WESTERN WEBER PLANNING COMMISSION

Staff Report to the Western Weber Planning Commission

Application Request: Consideration and action on a request for preliminary plan approval of Fall Widow Subdivision Phase 2

Exhibit F- Weber County Reviewer's Comments

Exhibit B- Proposed Improvement Drawings

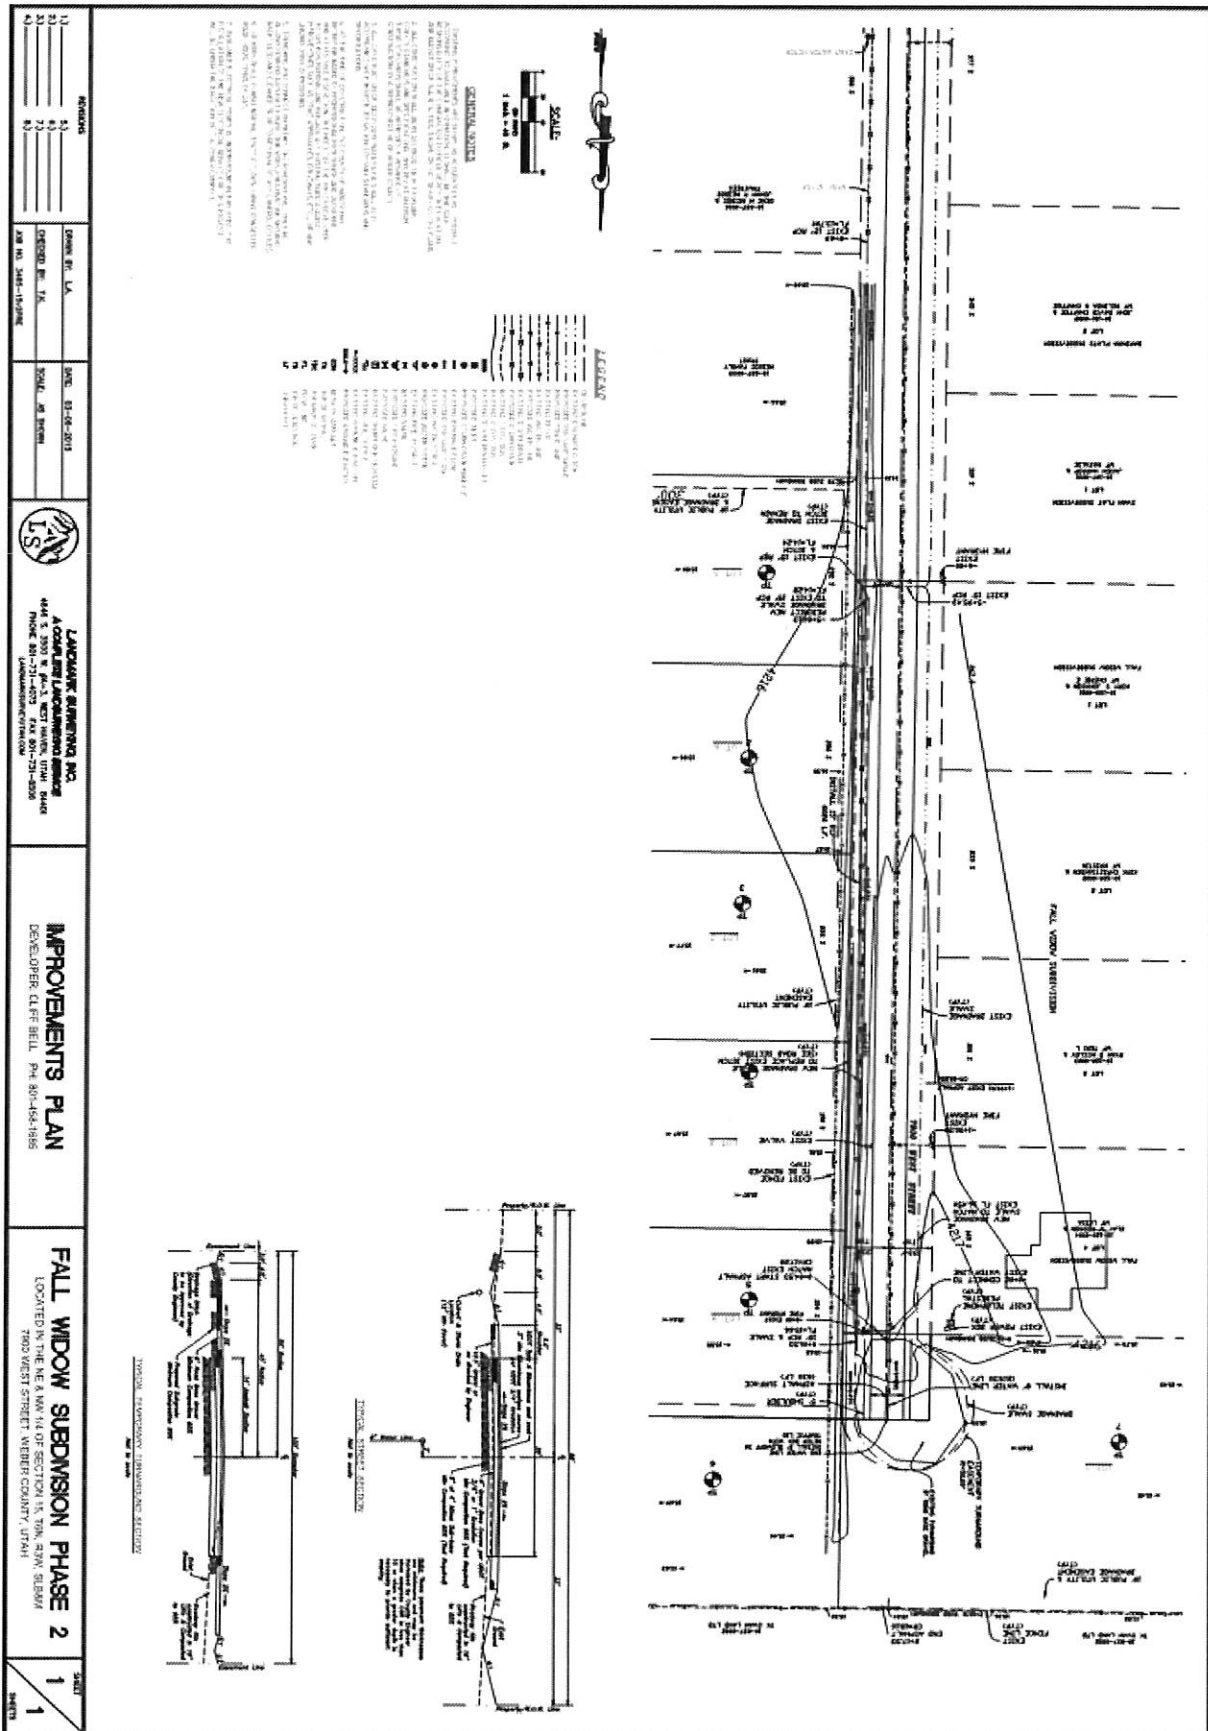
- I have had a chance to review the plan(s) and have the following comment(s): **Written responses to the following comments are required.**
1. The submitted improvement plan shows a proposed storm drain pipe and swale replacing an existing ditch; What is that existing ditch currently used for? Where does it come from and where does it go?

2. This road is too long to not have another access point. In order for more lots to be added to this road, a stub road through Barbara Flats Subdivision on the right of way which was dedicated at the time of recording needs to be built.

3. Plan and profile construction drawings will need to be submitted for review.
 4. I don't see a detention pond, how will storm water be handled?
 5. An excavation permit is required for all work done within the existing right-of-way.
